IEEE P802.3cg 10BASE-T1S Optional Increased Transmit Voltage

David D. Brandt, Rockwell Automation

Purpose

- The purpose of this presentation is to:
 - Propose changes in IEEE P802.3cg Draft 2.1 for the addition of an increased transmit voltage option for 10BASE-T1S
 - Augment suggested remedy for comments #441 and #180

1V Vpp
40*4.5pf
180pf Ctot

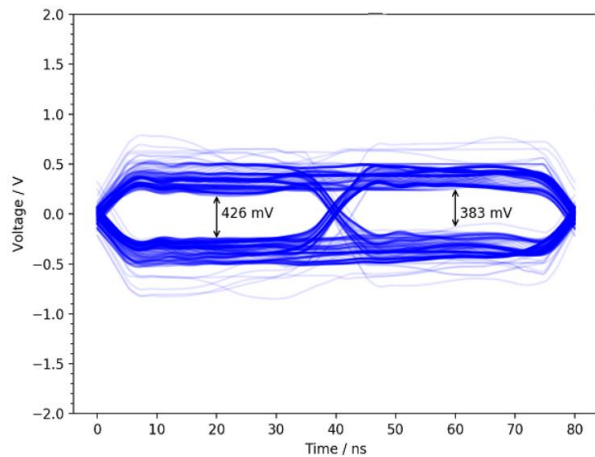
Composite Eye Openings

1 Vpp Versus 2.4 Vpp, various Ctot

Higher supply voltage is one enabling factor for higher node count

10BASE-T1S multidrop reach

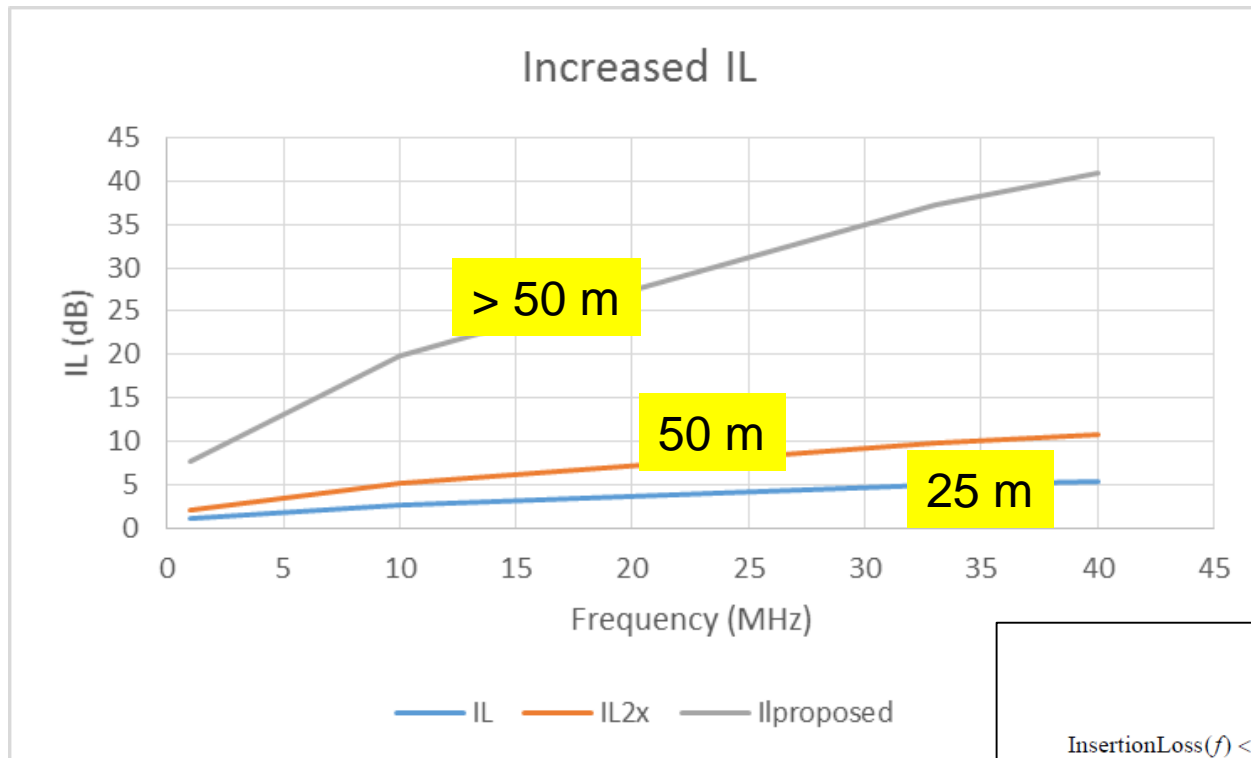
- Increased reach should be achievable (7.6x?)

- {Existing Clause text and Equation, modified as follows:
 - Change Equation reference to 147-3b
 - Change text preceding new equation 147-3b to the following: “For 2.4 Vpp differential transmit amplitude, the insertion loss of each 10BASE-T1S point-to-point link segment shall meet the values determined using Equation (147–3b).
 - Change Equation limits:
 - from “1.0 +” to “8.6 +”
 - from “2.6 +” to “10.2 +”
 - from “4.9 +” to “12.5 +”

PT-PT ANALYSIS AND PROPOSAL

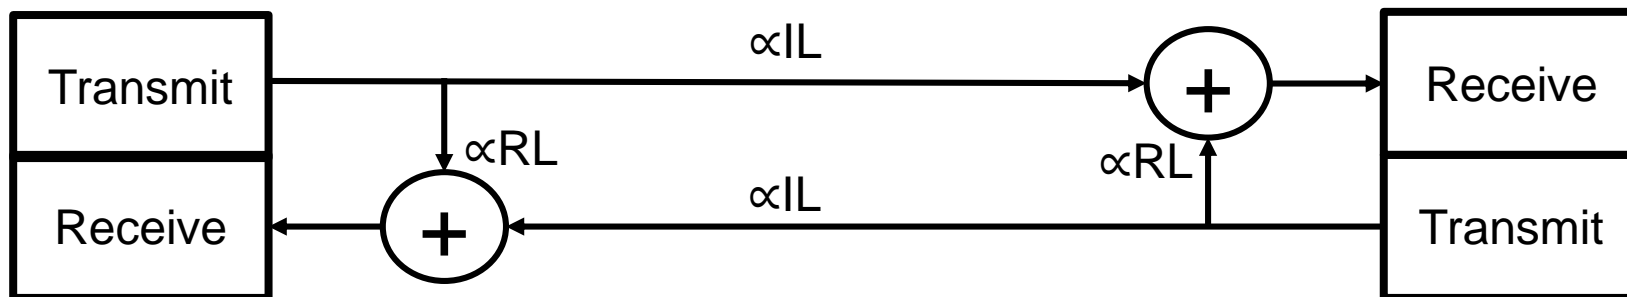
- An attenuated transmit signal is received, based on IL
- Receiver subtracts its own transmission (if any), but transmit reflections remain and are added to the receive signal
- Echo cancellation can compensate reflections
 - 10BASE-T1S has no defined echo cancellation method, but it is not precluded
- Receive threshold [compensated] must exceed reflection limit
- For 1 Vpp differential transmit signal:

- Without some measure, full-duplex communication may fail (echo may increase 2.4x)
- RL may be increased by 7.6 dB
 - Difficult specification to achieve
- Implementation-specific measures include a combination of:
 - Increased RX threshold
 - Cancels any reach gain from increased IL
 - Improves immunity *between* transmissions
 - Echo cancellation
 - Not standardized
 - Improves immunity *during* transmissions

- Rather than complicate 10BASE-T1S and increase link segment requirements - utilize 10BASE-T1L in demanding situations
 - Increased reach
 - Echo cancellation maintains reasonable RL
 - LSM AN uses lower complexity modulation than data transfer
 - Unshielded and shielded options
